Product Support Bulletins

May 1974 to September 2000

These Support Bulletins have changes that were not necessarily made before the manuals were printed.

INCORRECT VERSION

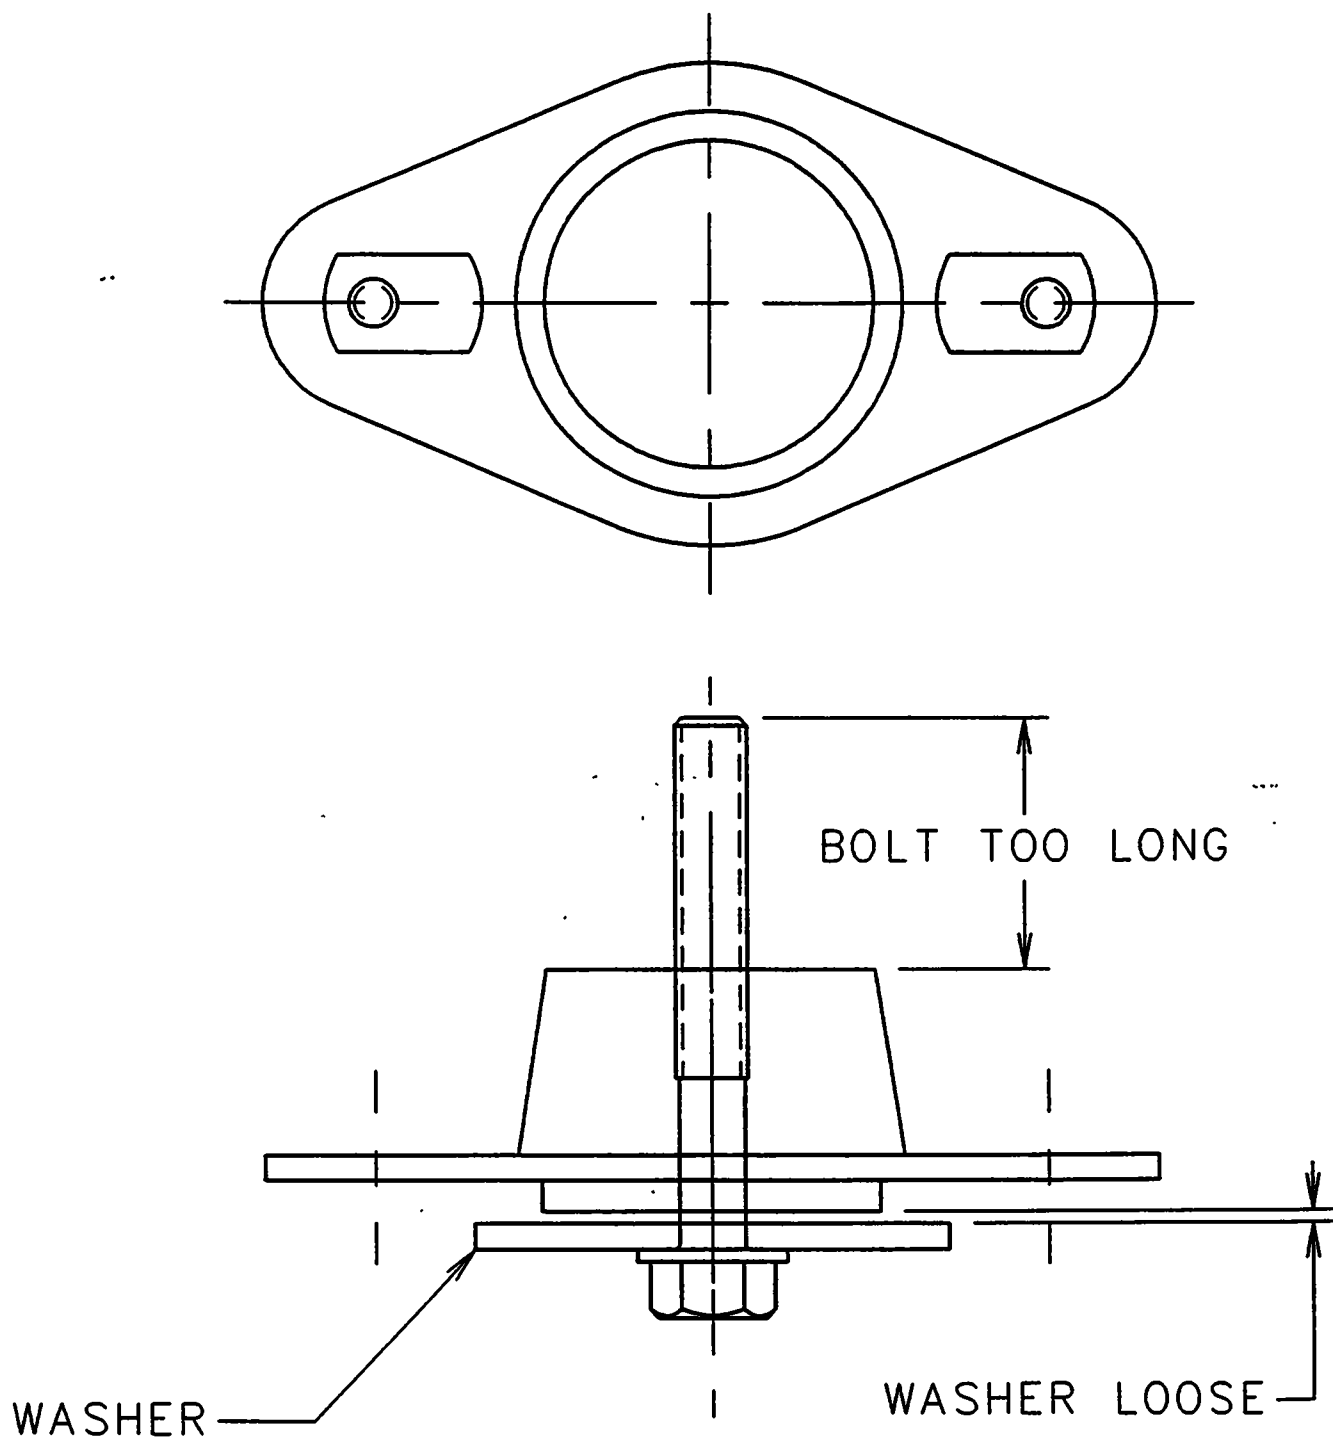
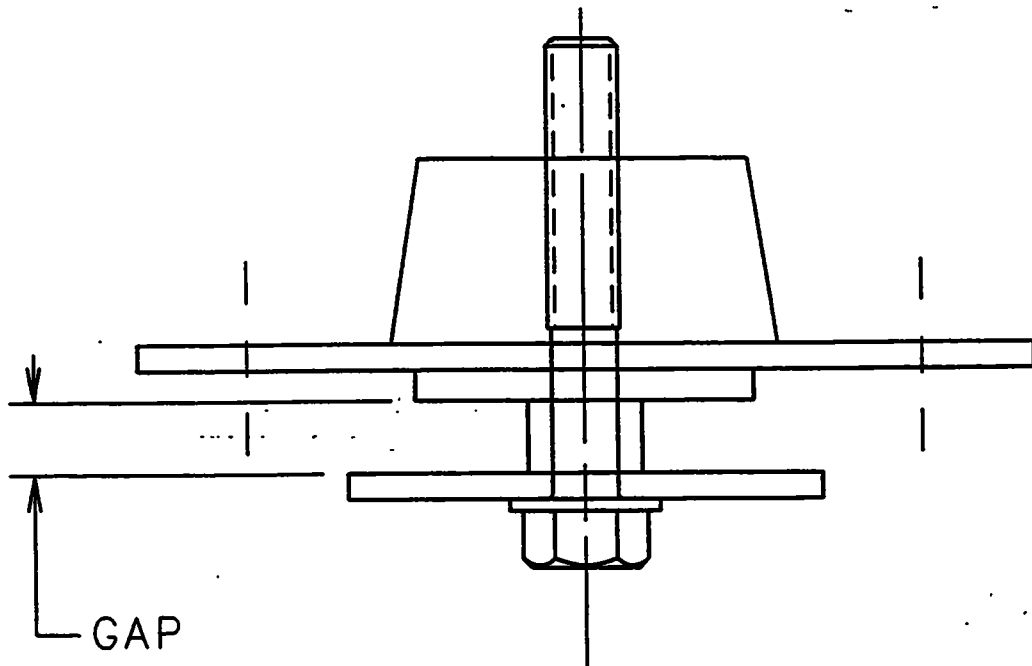
INCORRECT CONFIGURATION
